# Access Compliance Report

## Public Rights-of-Way

Intersection ID: N/A	Main Street: SOUTHGROVE ST	Cross Street: WAVERLY WALK AV	Location: SE
ADA ID: 210E136B8F53	Ramp Type: Perp	Initial Pass/Fail: Fail	Overall Compliance: No
Codes/Mitigation Info/Possible Solution		Field Measurements/Component Compliance

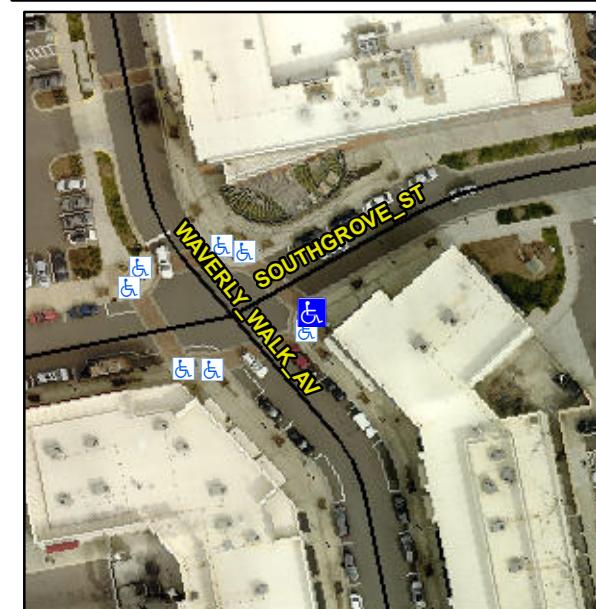
**R304.2.2, R304.5.3**

Compliance	Description	Data	Compliance	Description	Data
N/A	Ramp Length (in)	66.0	No	Ramp Slope (%)	9.2
Yes	Ramp Width (in)	48.0	No	Ramp XSlope (%)	2.6
N/A	Flare Type LT	N/A	N/A	Flare Type RT	N/A
N/A	Flare Slope LT (%)	N/A	N/A	Flare Slope RT (%)	N/A
N/A	Flare Traversable LT?	N/A	N/A	Flare Traversable RT?	N/A
N/A	Landing Length (in)	N/A	N/A	DWS Provided?	N/A
N/A	Landing Width (in)	N/A	N/A	DWS Contrast?	N/A
N/A	Landing Slope (%)	N/A	N/A	DWS Length (in)	N/A
N/A	Landing X Slope (%)	N/A	N/A	DWS Full Width?	N/A
N/A	Landing Curb? (Y/N)	N/A	N/A	DWS Offset (in)	N/A
N/A	Shared Landing?	N/A			
N/A	Gutter Ponding?	N/A	N/A	Gutter Slope (%)	N/A
N/A	Gutter Lip Ht (in)	1.0	N/A	Gutter X Slope (%)	N/A
N/A	Painted X Walk1?	Yes	N/A	Painted X Walk2?	N/A
	X Walk 1 Direction	To NW		X Walk 2 Direction	N/A
N/A	X Walk 1 Width (in)	103.5	N/A	X Walk 2 Width (in)	N/A
	X Walk 1 Slope (%)	0.4		X Walk 2 Slope (%)	N/A
	X Walk 1 X Slope (%)	2.2		X Walk 2 X Slope (%)	N/A

**Remove & Replace Entire Ramp.**
